TECHNICAL INFORMATION

SUBJECT: Starter assembly and its related parts on **ECHO CS-590, CS-600S, CS-620SX and shindaiwa 600sx**

Number: Y2019-670(1/3)

Changed bolts and added collars on starter case for tightening more securely.
 Changed starter grip, oil cap and fuel cap for parts unification.

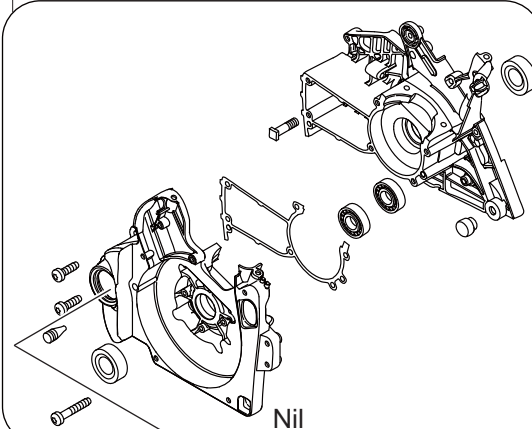
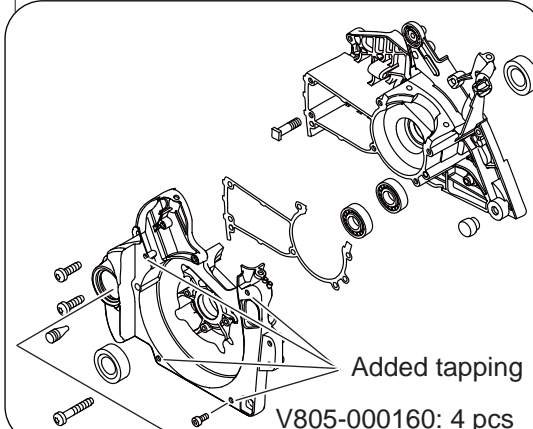
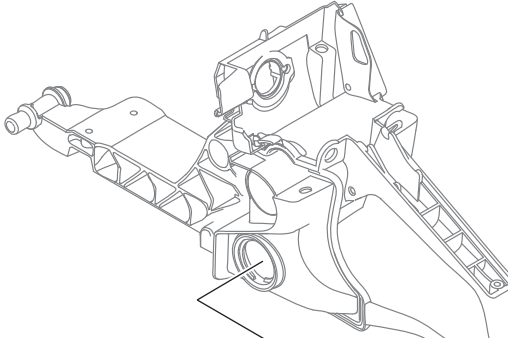
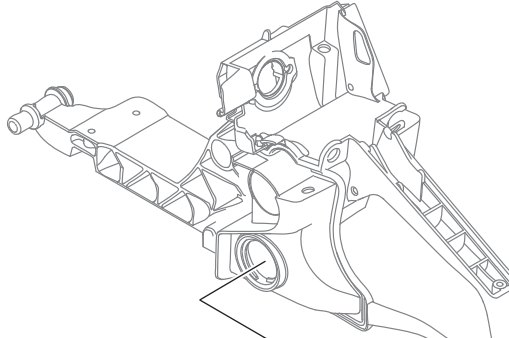
Recoil starter assembly	Nil	P200-001010: for ECHO P200-001020: for shindaiwa
<p>When assembling new fan cover A172-000843 on the units before this change, refer to contents on page 3. And choose one of following ways.</p> <ol style="list-style-type: none"> 1. Process starter assembly. 2. Assemble recoil starter assembly P200-001010 (for ECHO model) or P200-001020 (for shindaiwa model). <p>Starter case P021-047600 (for ECHO model) or P021-049830 (for shindaiwa model) is superseded by recoil starter assembly P200-001010 (for ECHO model) or P200-001020 (for shindaiwa model). Starter assembly P021-041832 (for ECHO model) or P021-041842 (for shindaiwa model) is superseded by recoil starter assembly P200-001010 (for ECHO model) or P200-001020 (for shindaiwa model).</p> <p>A set of fan cover A172-000843, starter grip A511-000300, starter case P100-007940 (for ECHO model) or P100-008050 (for shindaiwa model) can be used on the units before this change.</p>

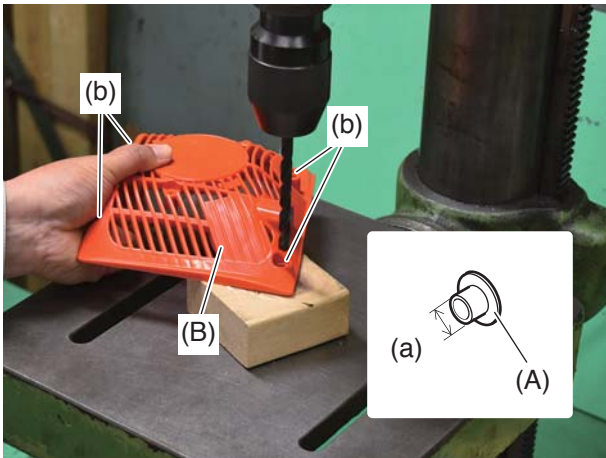
<p>Crankcase set</p>	<p>P100-007330: CS-590 P021-043800,P021-043801,P021-043802 : CS-600S P021-044011 or P021-044012: CS-620SX P021-045100 or P021-045101: 600sx</p>  <p>Nil</p>	<p>P200-000980: CS-590 P200-000920 : CS-600S P200-000940: CS-620SX P200-000950: 600sx</p>  <p>Added tapping V805-000160: 4 pcs</p>
<p>Torx bolt</p>	<p>900246-03008</p>  <p>131051-19830</p> 	<p>Nil</p>  <p>A365-000050</p> 
<p>Screw</p>	<p>131050-19830</p> 	<p>Nil</p> 
<p>Cap connector</p>	<p>900720-00028</p> 	<p>Nil</p> 
<p>Link retainer</p>	<p>P021-016031</p> 	<p>P100-004881</p> 
<p>O-ring</p>	<p>900720-00028</p> 	<p>900720-20029</p> 
<p>Oil cap</p>		
<p>Screw</p>	<p>900246-03008</p> 	<p>Nil</p> 
<p>Cap connector</p>	<p>131051-19830</p> 	<p>A365-000050</p> 
<p>Link retainer</p>	<p>131050-19830</p> 	<p>Nil</p> 
<p>O-ring</p>	<p>900720-20029</p> 	<p>V581-000600</p> 
<p>Fuel cap</p>	<p>P021-016041: for ECHO P021-016681: for shindaiwa</p> 	<p>P100-004891: for ECHO P100-006351: for shindaiwa</p>

Crankcase set P100-007330 can be replaced with P200-000980.
Crankcase set P021-043800, P021-043801 or P021-043802 can be replaced with P200-000920.
Crankcase set P021-044011 or P021-044012 can be replaced with P200-000940.
Crankcase set P021-045100 or P021-045101 can be replaced with P200-000950.
Oil cap P100-004881 can be used on the unit before this change.
Fuel cap P100-004891 or P100-006351 can be used on the unit before this change.

How to assemble former starter case (P021-047600 or P021-049830) and current fan cover (A172-000843)

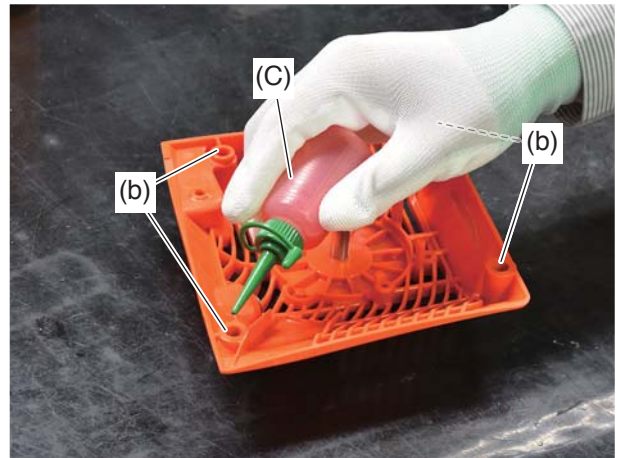
1. Measure collar V353-000760 outer diameter (a). Confirm the outer diameter (a) is about 7.5 mm.
2. Widen 4 holes (b) of starter case P021-047600 (B) using drill bit sizes 7.5 mm, to fit collar V353-0000760 (A).

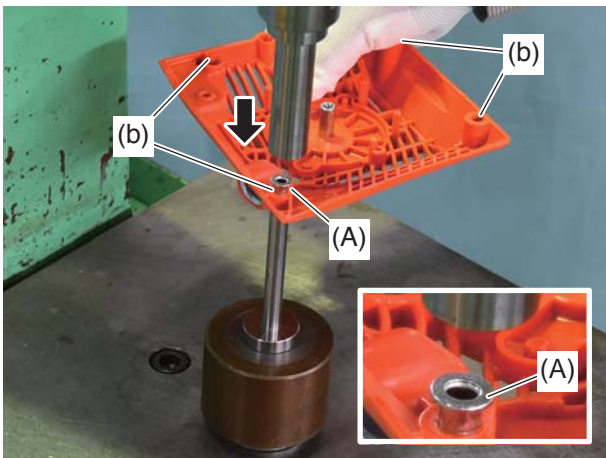
3. Apply adhesive Loctite 242 or equivalent (C) in holes (b).

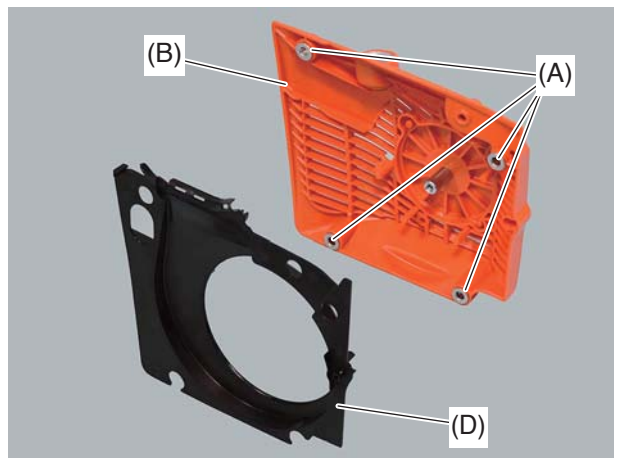
4. Press 4 pcs of collar V353-0000760 (A) in holes (b).

5. After assembling related starter parts to starter case (B) with 4 pcs of collar (A), assemble fan cover A172-000843 (D).
